**November 3, 2015**

**ADDENDUM NO. 3**

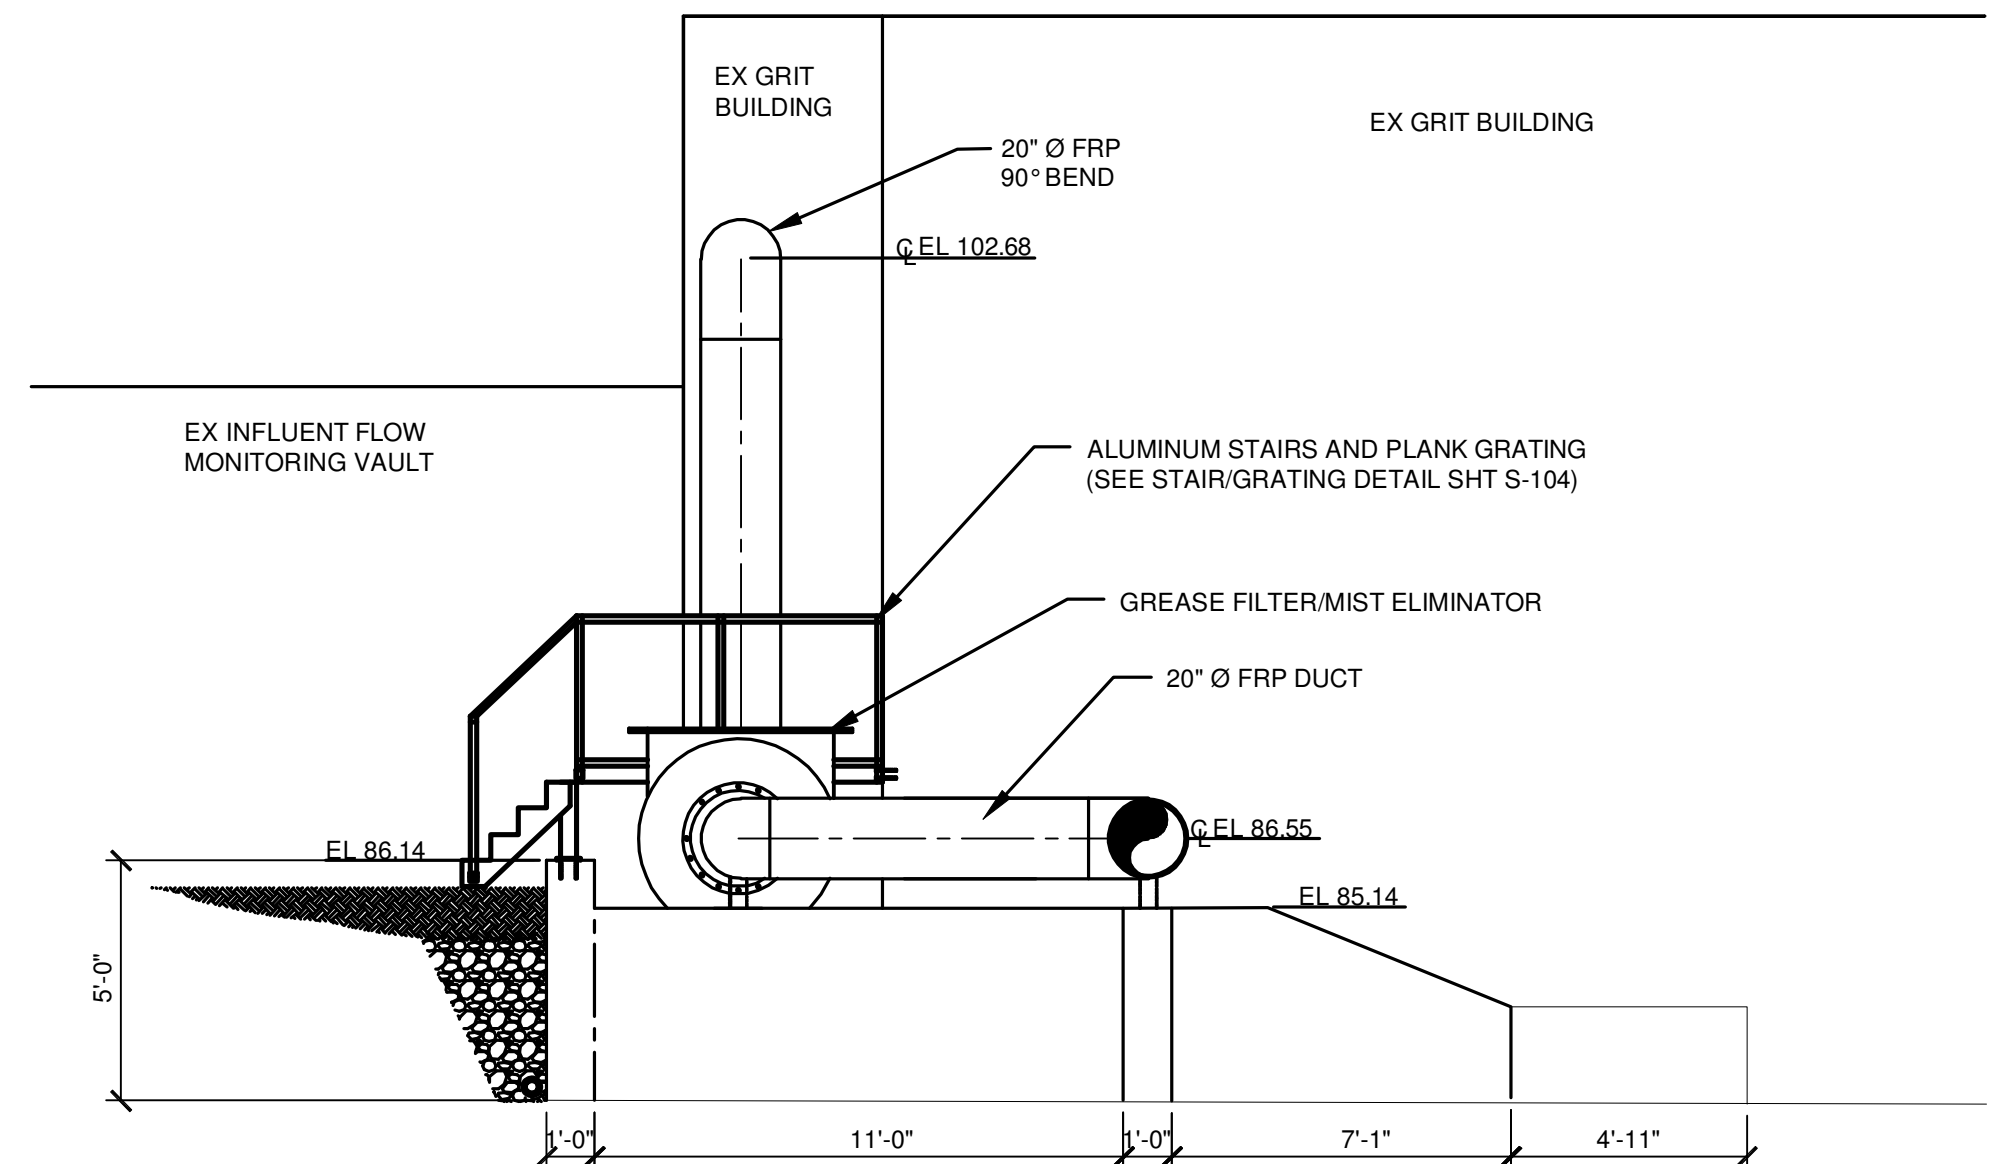
IN CHARGE OF	WAD				
DESIGNED BY	WAD/DRB				
CHECKED BY	RWR				
DRAWN BY	G.J.L.				
NO.	0	DATE	11/03/2015	ADDENDUM NO.	3
REVISION					
WAD					
INT.

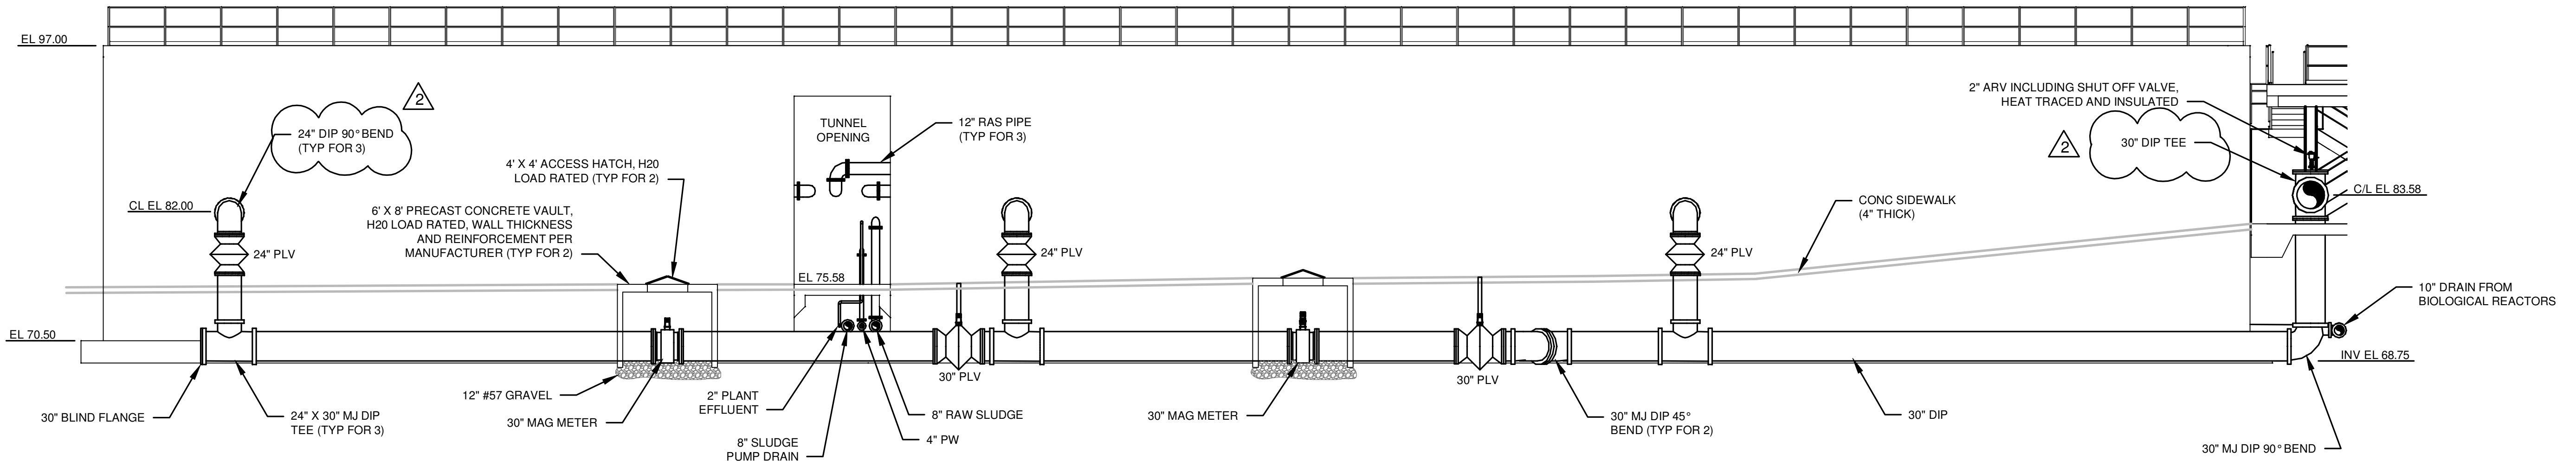
IN CHARGE OF	WAD				
DESIGNED BY	DBK				
CHECKED BY	PCC	2	11/03/2015	ADDENDUM NO. 3	DBK
DRAWN BY	JAM	1	09/23/2015	ISSUED FOR BID	DBK
		0	03/19/2015	ISSUED FOR OEPA REVIEW	DBK
		NO.	DATE	REVISION	INT.
